Accessibility Survey

City of Downey Flores Street - Erickson Avenue to End

Date of Inspection
7/7/2017

Prepared By
Disability Access Consultants
(800) 743-7067

Change in Level East of End @ 33.925525857746, -118.163924217224

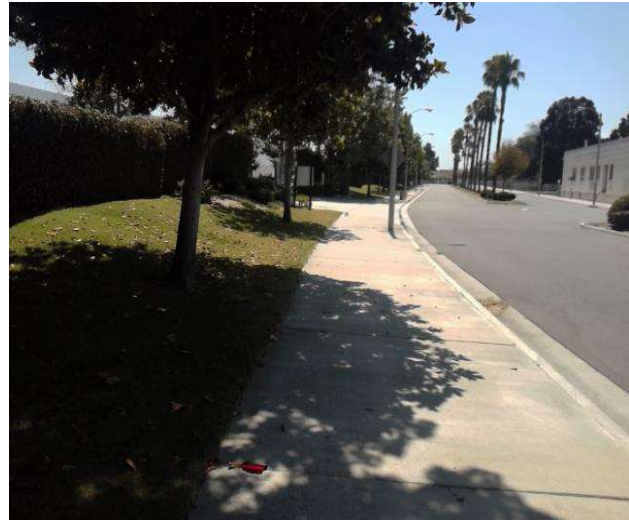
There is a change in elevation greater than recommended value.

On-Site Finding 0.62 inches

Ensure that the change in elevation is within the recommended value.

Recommendation Up to 0.25 inches

North Side East of End - 1st @ 33.925623784078, -118.166075348854

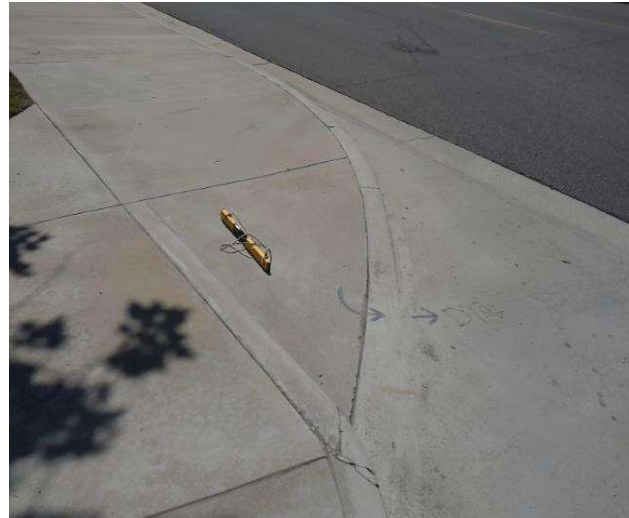
The running slope is greater than allowed.

On-Site Finding 10.80 percent

Provide a compliant curb ramp.

Recommendation Up to 8.33 percent

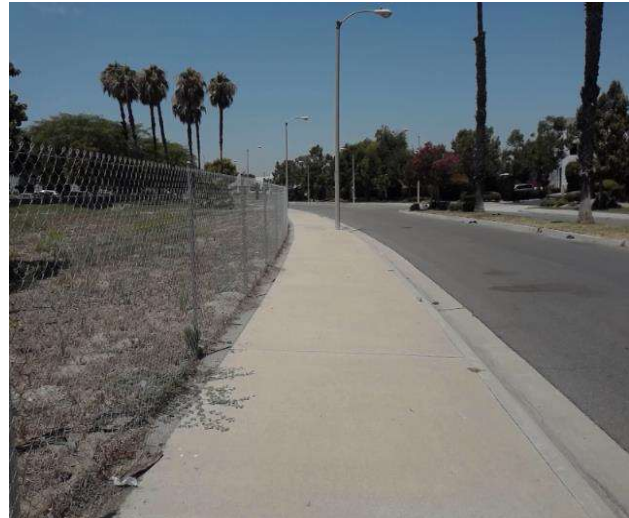
Sidewalk cross slope is not compliant.

On-Site Finding 3.20 percent for 150.00 feet

Repave the sidewalk surface with the recommended cross slope.
